# SERVICE BULLETIN

<b>SERVICE BULLETIN</b>		No.: ESB-97E51-501	
		Date: 1998-03-15	<Model> <M/Y>
<b>Subject:</b>	CENTER CONSOLE PANEL AND CUP HOLDER REMOVAL	(EC,EXP) CARISMA	96-10
<b>Group:</b>	INTERIOR		
<b>CORRECTION</b>	 O. Kai - E.V.P. & G.M. After Sales Service Dept.

This Service Bulletin informs you of addition of a removal procedure for the center console panel and cup holder assembly

**◀ A ▶ CENTER CONSOLE PANEL AND CUP HOLDER ASSEMBLY REMOVAL**

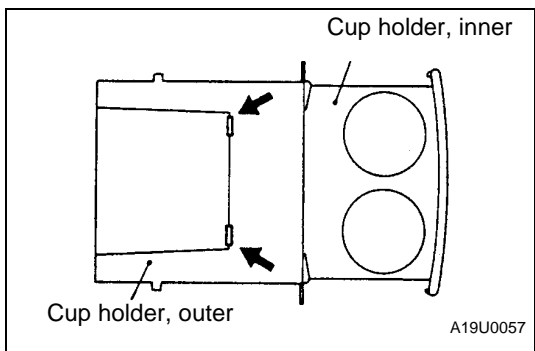
- ▶ 1. After removing the center console mounting screws, pull the center console panel towards you to remove it together with the cup holder, inner
- ▶ 2. Insert a screwdriver into the space as shown in the illustration to remove the center console panel and cup holder assembly

**◀ B ▶ CUP HOLDER, INNER REMOVAL**

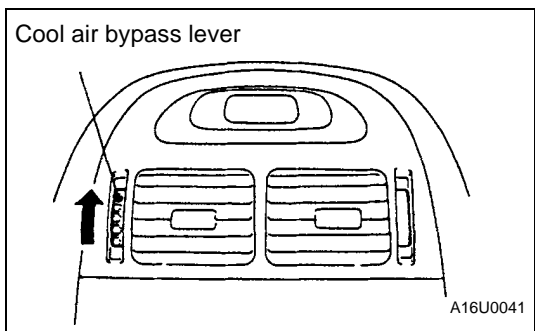
Push the cup holder, outer in the places shown in the illustration to remove the cup holder, inner.

**▶ A ◀ CENTER AIR OUTLET ASSEMBLY INSTALLATION**

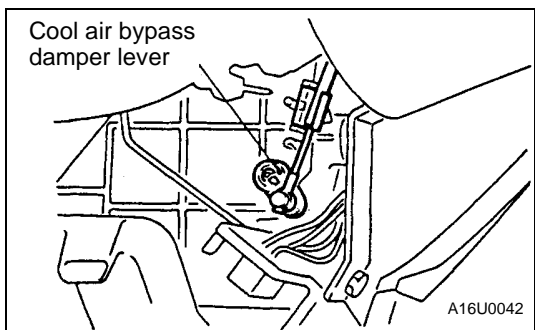
1. Turn the cool air bypass lever of the center air outlet assembly fully upward.
2. Turn the cool air bypass damper at the heater unit side fully downward, and install the cool air bypass lever cable.

<Added>

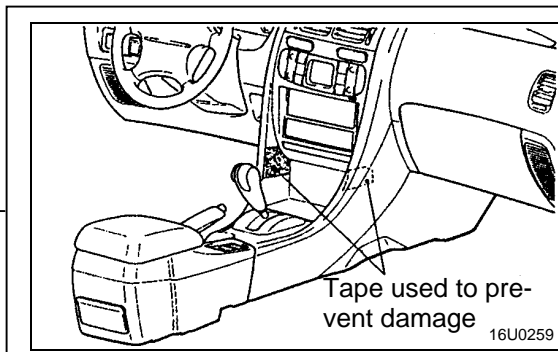
1. Affix a tape to the front floor console assembly to prevent it from being damaged.
